Reed Avenue Rail Corridor – 6th Penny Work Session

October 10, 2025

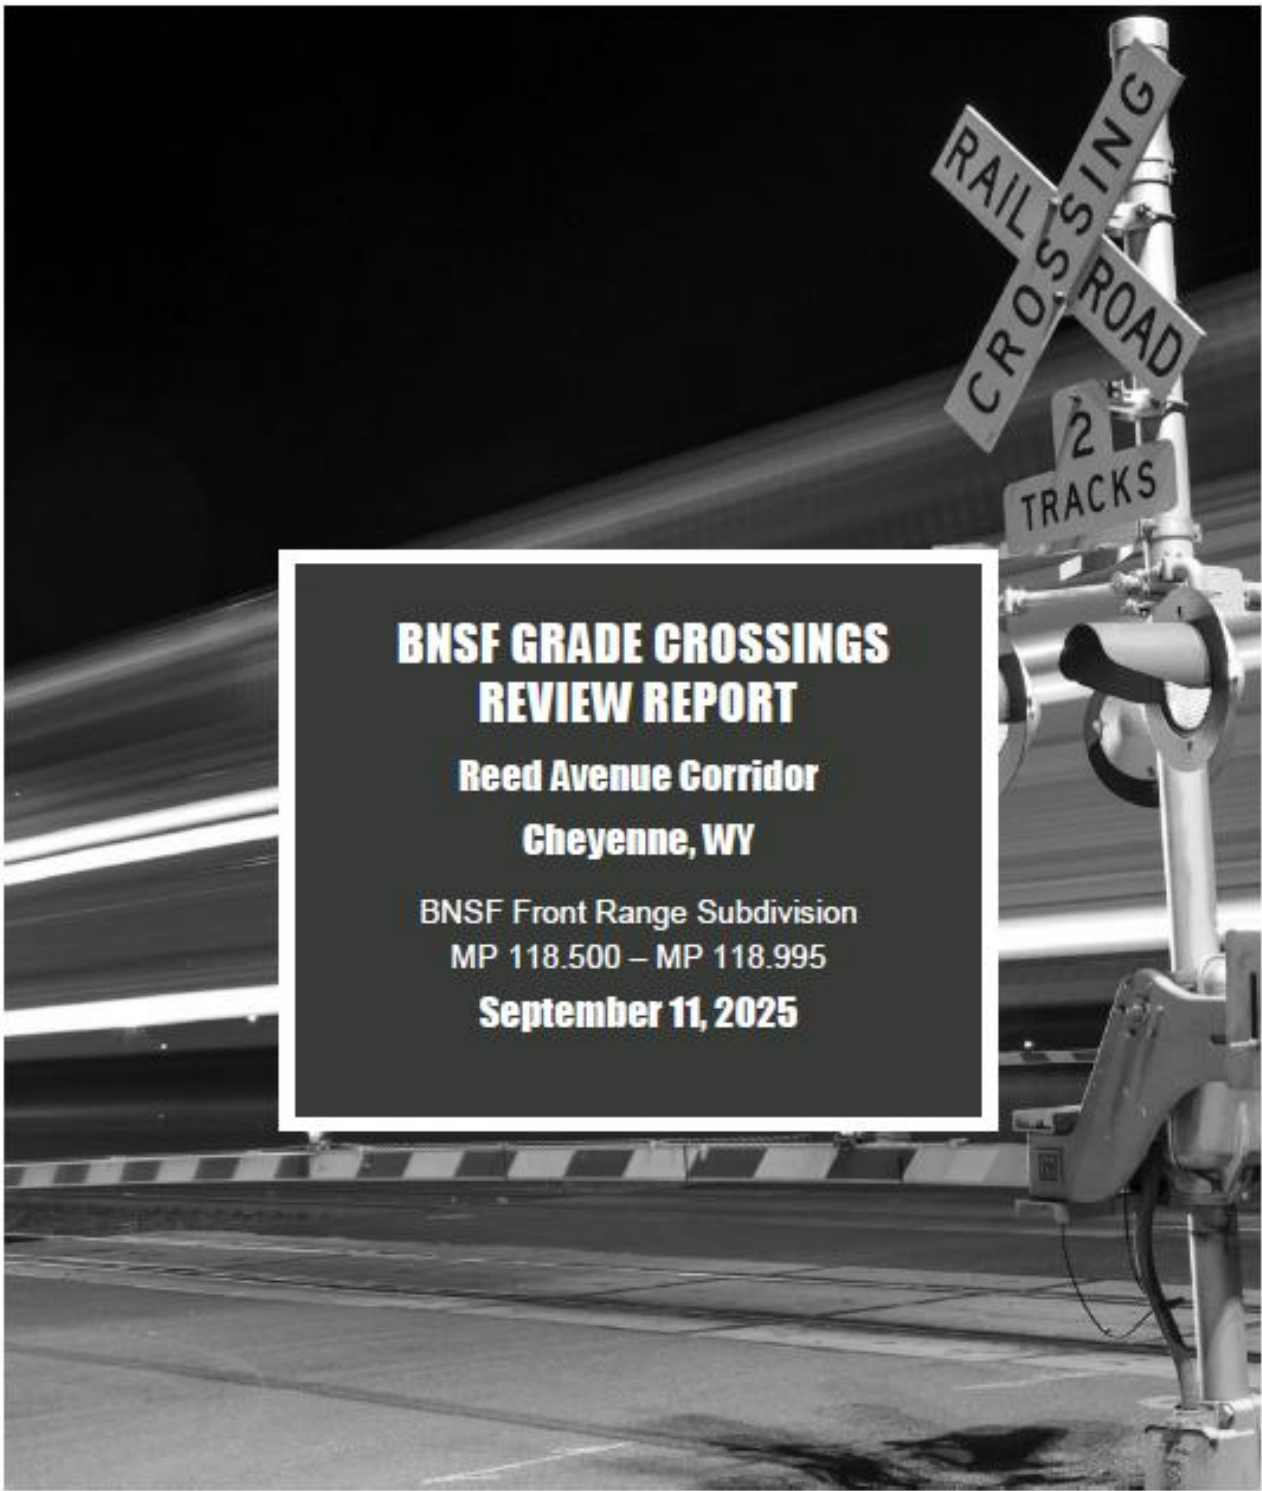
- 30% Plan BNSF/ Olson Comments
 - 72 Primary Comments and Suggestions Received
- Immediate Safety Actions
 - Remove signage encouraging unauthorized vehicle use along Reed Avenue.
 - Install “No Trespassing” signs on BNSF property.
 - Coordinate with property owners to adjust delivery operations near closed crossings.
 - Provide project history and intent documentation.

Grade Crossing Report Initial General Summary Table Reed Avenue Crossings, Cheyenne, Wyoming Reed Avenue Corridor Grade Crossings, Front Range Subdivision				
No.	Comment or Revision No.	BNSF Team Recommendation	Standard/Reference	Owner's Response (Y/N)
1	Immediate Action Item	Per diaphanous meeting minutes, the City should remove all signs facilitating the unauthorized use of the crossing.	Diaphanous Meeting	
		Provide status of coordination with property owners to change delivery operations due to 24th Street grade crossing closure. If delivery operations cannot be changed immediately, property owners should be notified.	Diaphanous Meeting

Item	Add "BNSF Property - No Trespassing" signs to Reed Avenue on both sides of the crossing.	Diaphanous Meeting	
	Item	Provide a project report to explain the history of the redevelopment project that is currently underway, history of the crossing, and the crossing's future.	Diaphanous Meeting	
		Per diaphanous meeting minutes, provide lighting.	Diaphanous Meeting	
		Provide Grade Crossing Exhibit detailing additional design details related to grade crossing, including lane widths, sidewalk widths, placement of crossing devices from	Recommended Practice	
		Provide Signage and Striping plan for 24th Street.		
		Provide track layout, including all crossings.		
		Specify BNSF ROW on all crossings.	Standard Practice	
		Reference to all utilities on the design plan sheets.	Recommended Practice	
		Provide detailed signage and striping plans for all crossings. Include all	For identification/revision purposes

existing signage and include		
		install detectable warning surfaces at the pedestrian approach to the grade crossing to be 2' upstream of grade crossing warning devices. For the off	MUTCD 8D.04 (2003) (Guidance): United States Bureau of Road and Transportation Builders Association Guidelines for Pedestrian Facilities (2011) DOT	
		Grade crossing surfaces used to extend at least 4' beyond sidewalk limits. Specify overall proposed crossing surface length in B-105 (overlaps due to	Standard Practice	
		Label each grade crossing DOT # and BNSF Subdivision on all sheets.	Standard Practice	
		Consider providing E crossing outside of grade crossing right-of-way.	ASHRAE 90.1-2010 as a Minimum Design of Highway and Streets (2011) Section 5.9.5	
		Per diaphanous meeting, specify the signage and/or	Diaphanous Meeting

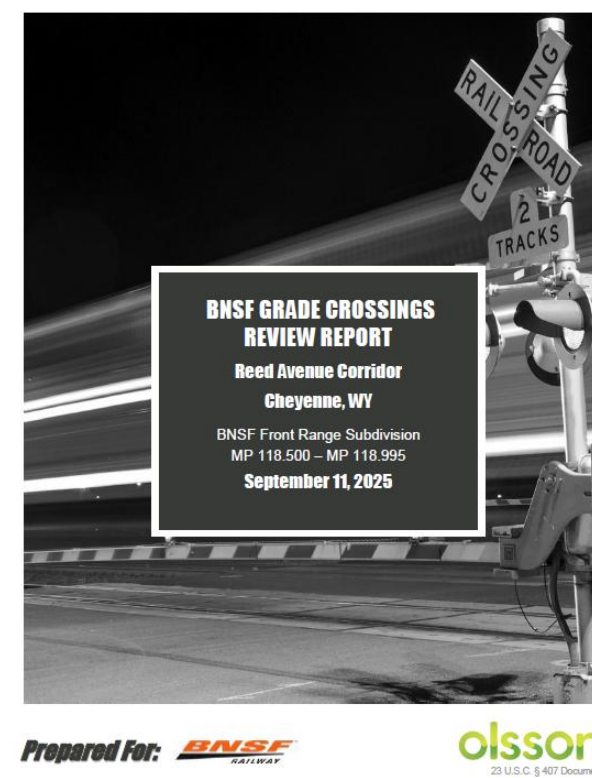
- **30% Plan Comments BNSF/ Olson (Cont.)**
- **Design and Plan Revisions**
 - Add detailed grade crossing exhibits: lane widths, sidewalk widths, gate lengths, and device placements.
 - Include signing and striping plans for all crossings, especially 23rd Street.
 - Specify BNSF right-of-way (ROW) and utility references on all plan sheets.
- **Pedestrian and Accessibility Enhancements**
 - Install detectable warning surfaces at pedestrian approaches.
 - Ensure sidewalk routing behind gate mechanisms with proper clearances.
 - Consider active pedestrian warning devices in quadrants without vehicle gates.

- **Railroad Equipment and Access**
 - Review and potentially relocate signal bungalows.
 - Provide mountable curbs and maintenance access for BNSF.
 - Clarify pedestrian access restrictions and fencing near crossings.
- **Sight Distance and Landscaping**
 - Eliminate or reduce landscaping near crossings to maintain clear sight lines.
 - Provide unwalkable surfaces (e.g., ballast or decomposed granite) around warning devices.
- **Traffic Operations and Queuing**
 - Perform queuing analyses for 19th and 22nd Streets to assess vehicle stacking risks.
 - Adjust striping and signage to reflect intersection-like conditions at crossings.

- **Tunnel and Structural Considerations (Lincoln Way)**

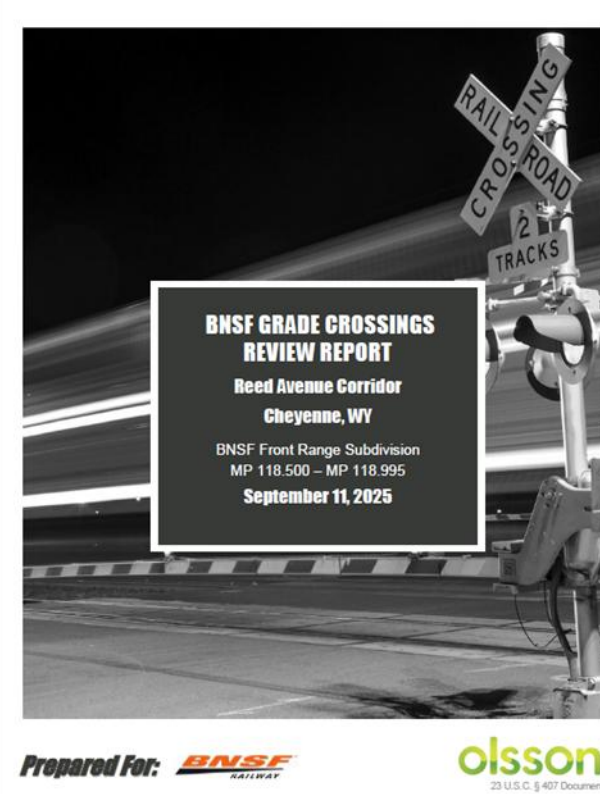
- Provide tunnel depth details, cross-sections, and construction methods.
- Confirm no conflicts with existing cantilever foundations or utilities Design and Plan Revisions

- 21st Street Closure Review - Warehouse 21

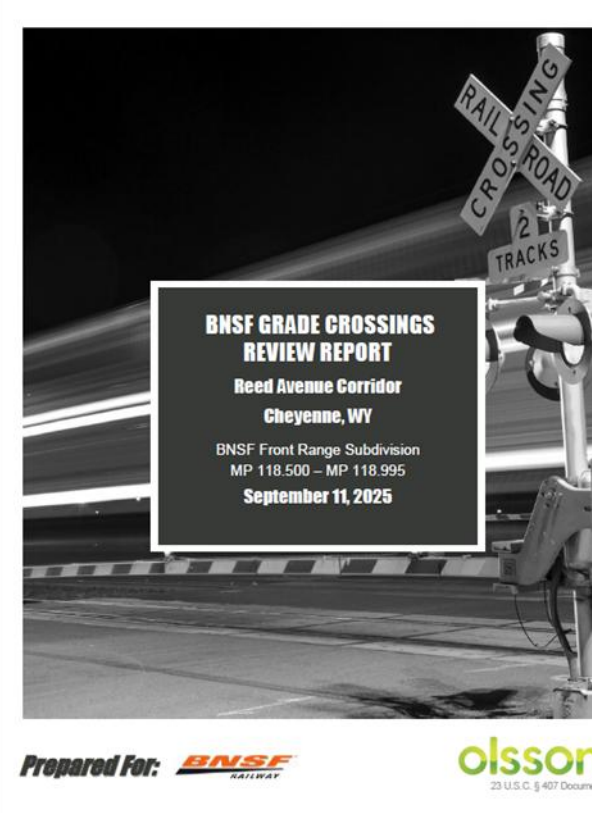
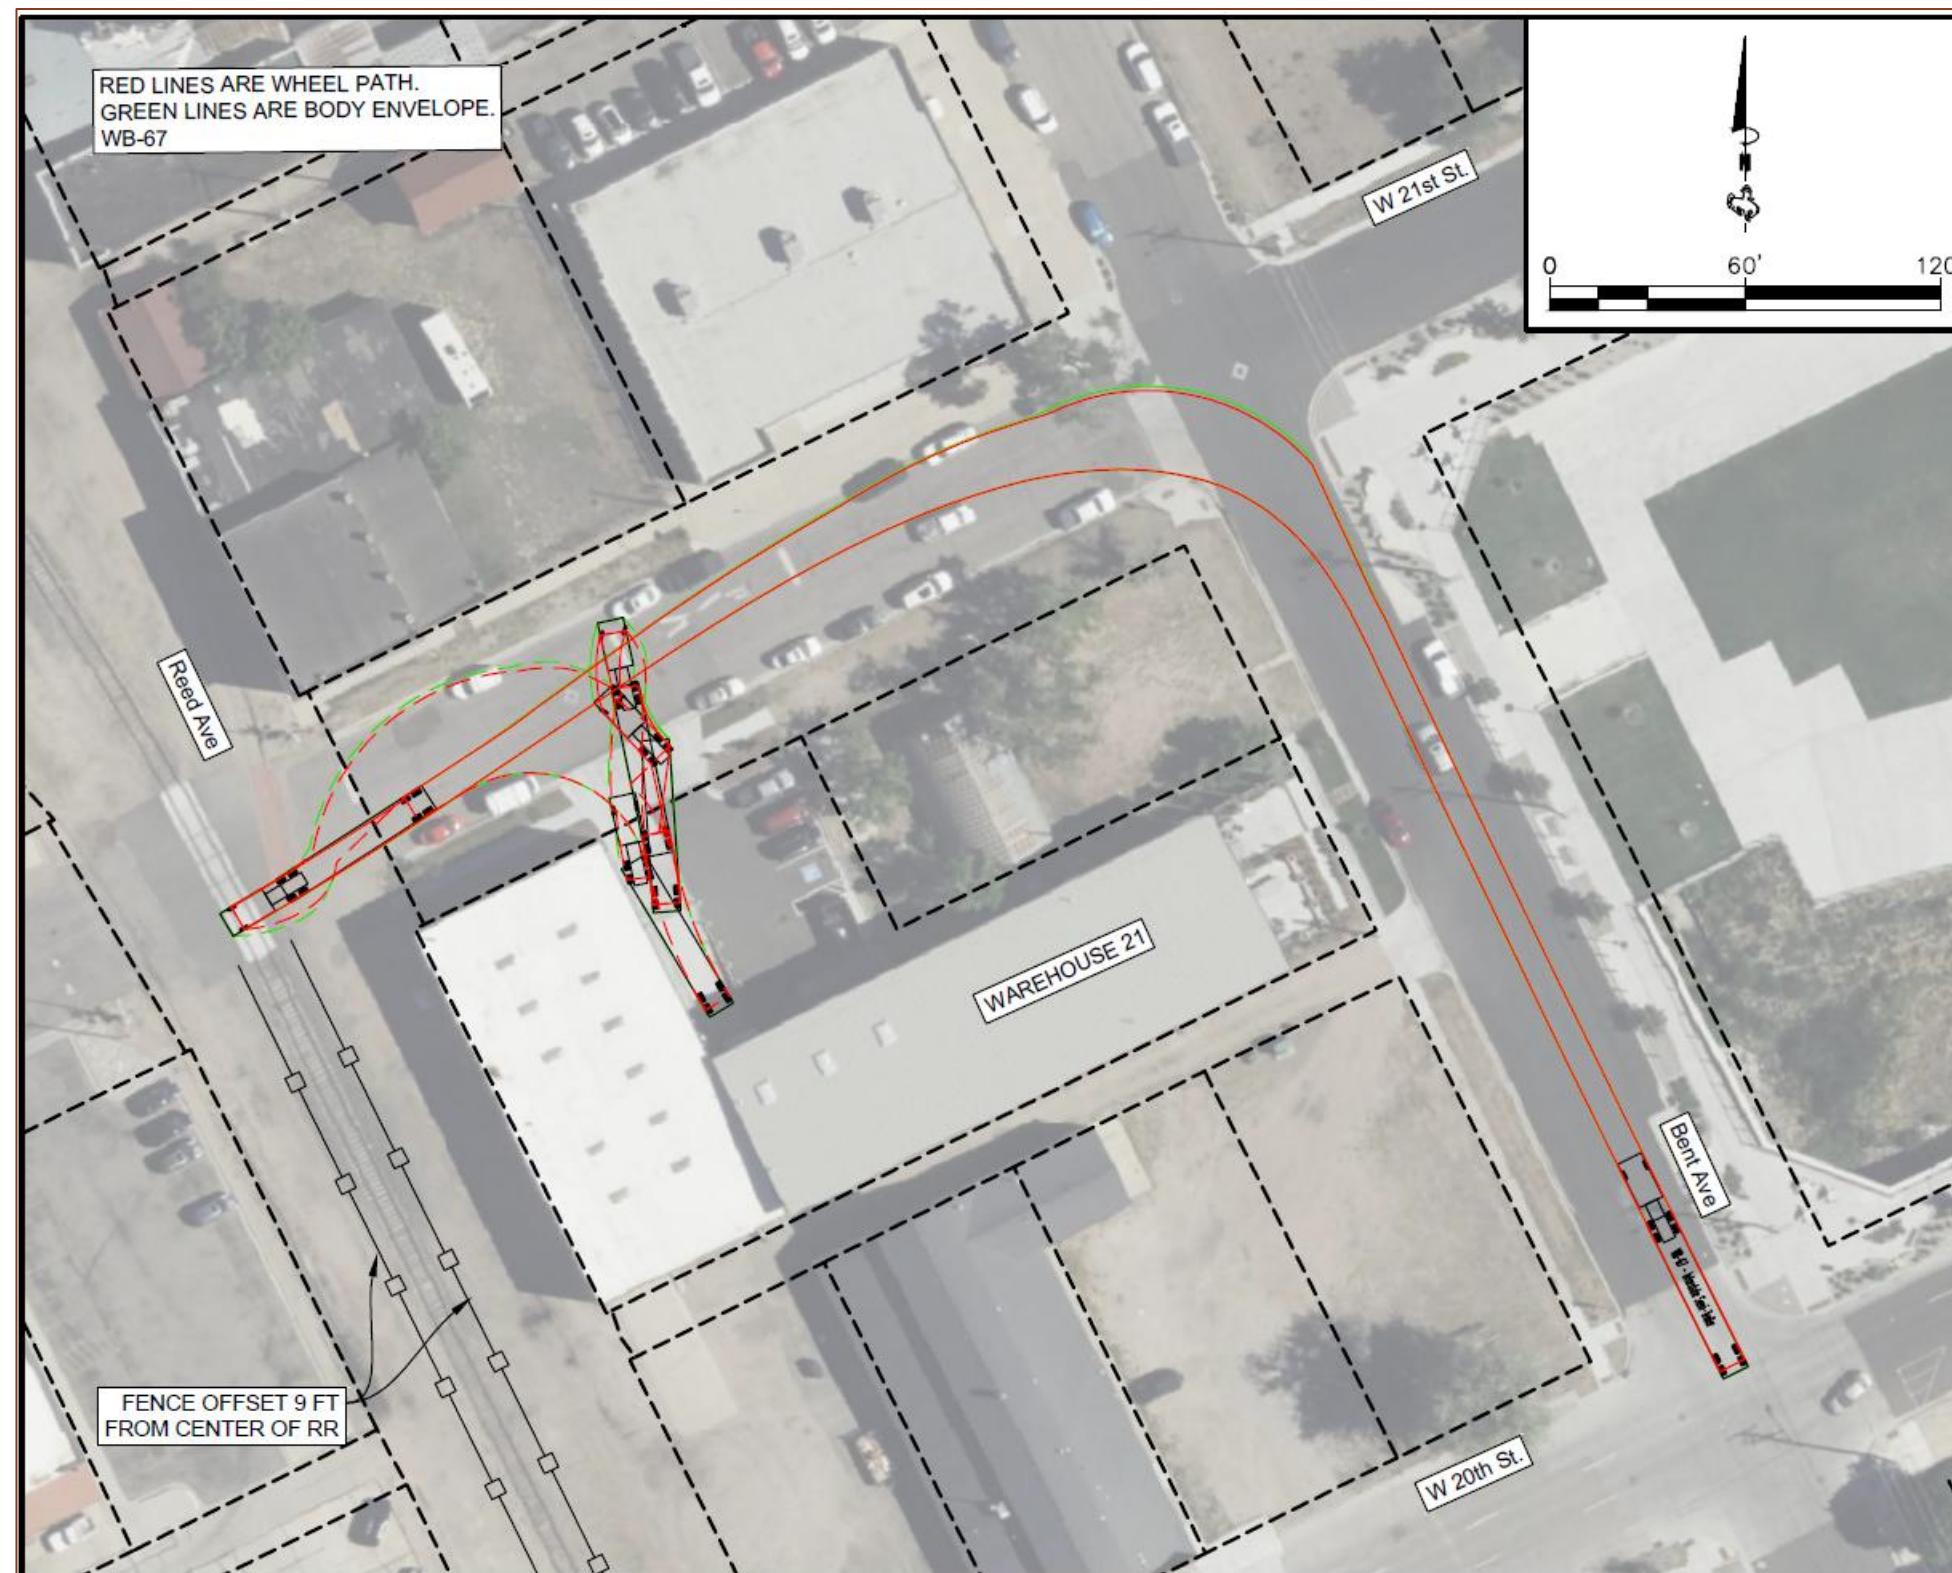
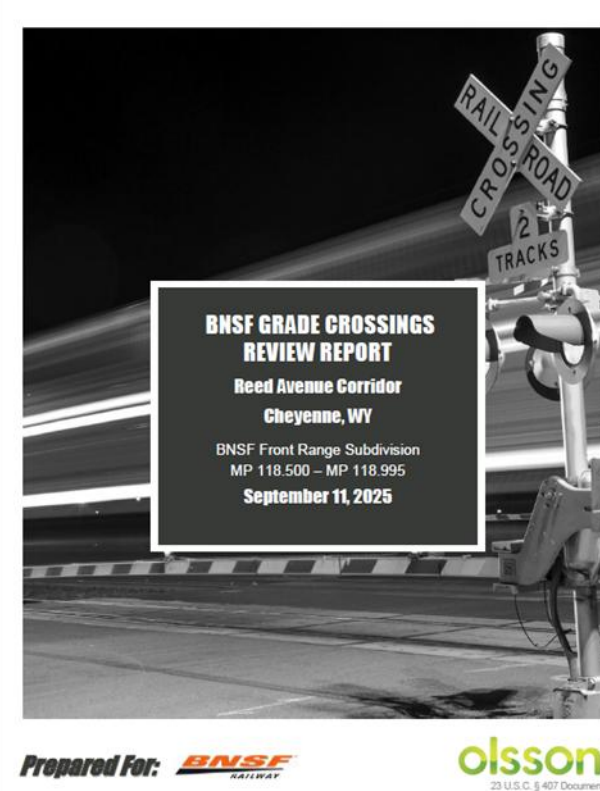
- Single-unit trucks (30–40 ft)
- Interstate semi-trailers (up to 67 ft)

- Large semi-trailers cross the BNSF corridor 3–4 times/month, depending on client needs.

- East to West: Requires encroachment into BNSF property to back into the dock.
- West to East: Crosses BNSF corridor but does not encroach during backing.

- 21st Street Closure Review – Meadow Gold

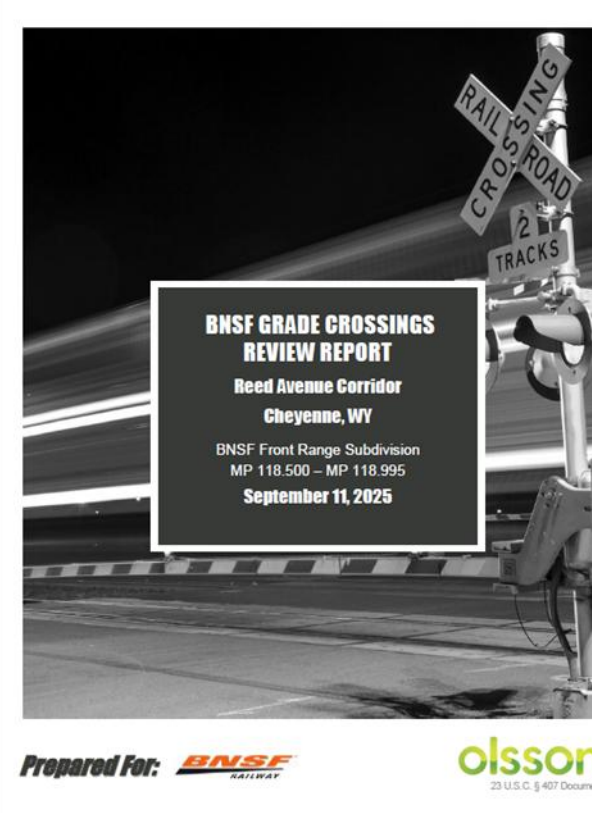
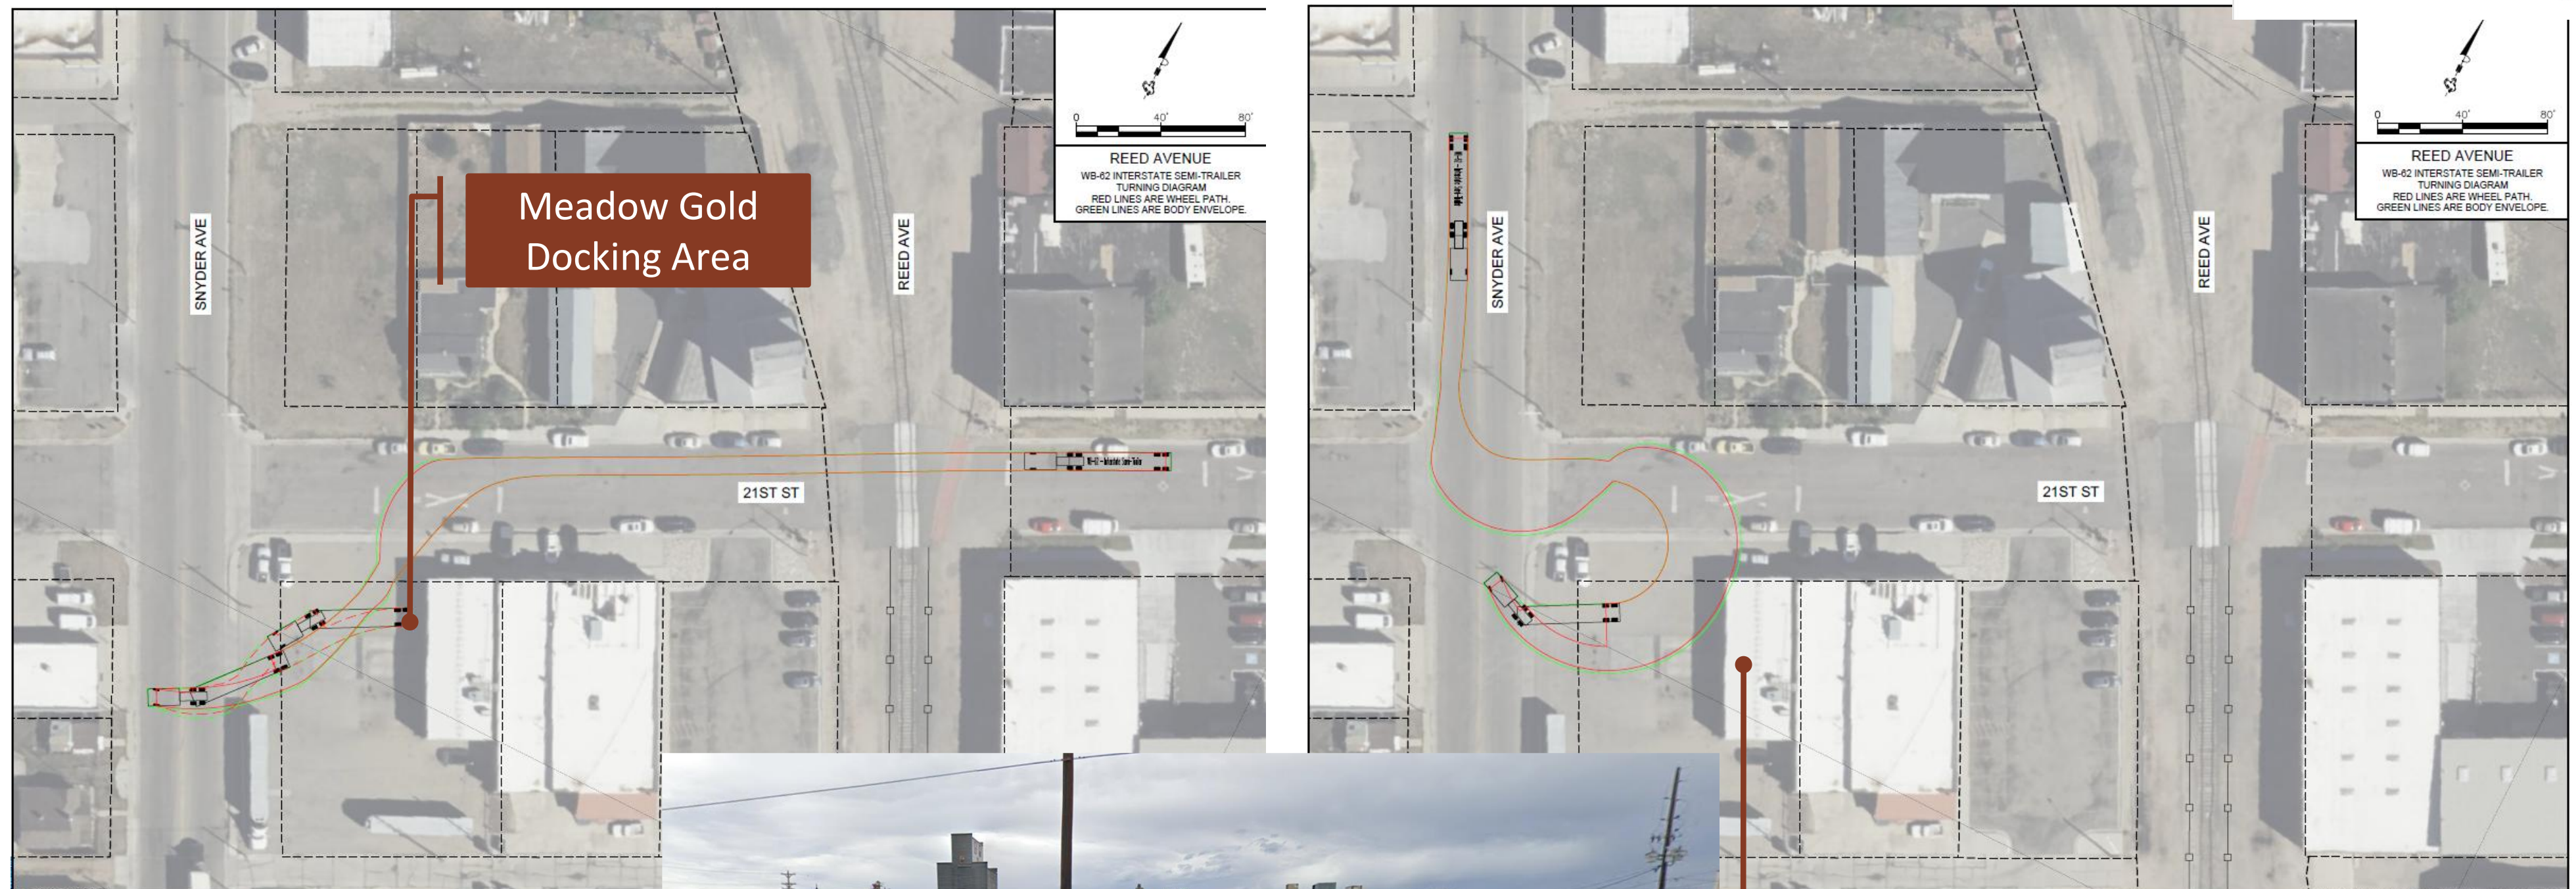
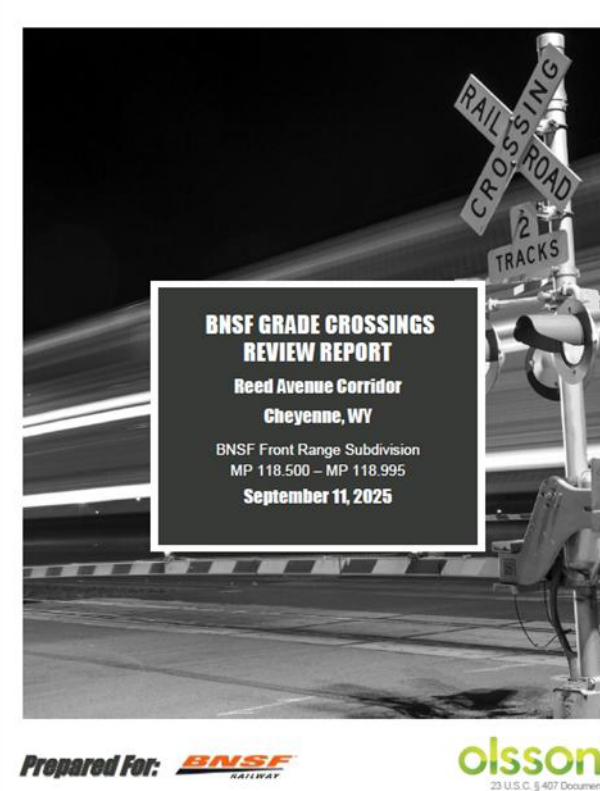
- Single-unit trucks (≈30 ft)
- Semi-trailers (up to 62 ft)

- Large semi-trailers cross the BNSF corridor ≈4 times/day, based on demand.

- East to West Route:
 - Crosses BNSF corridor to access north business approach
 - Exits via second approach onto Snyder Ave
 - Performs back-in maneuver to lower docks
- North to South Route
 - Utilizes Unsafe Maneuvers within Snyder Right-of-way
 - Difficult to navigate
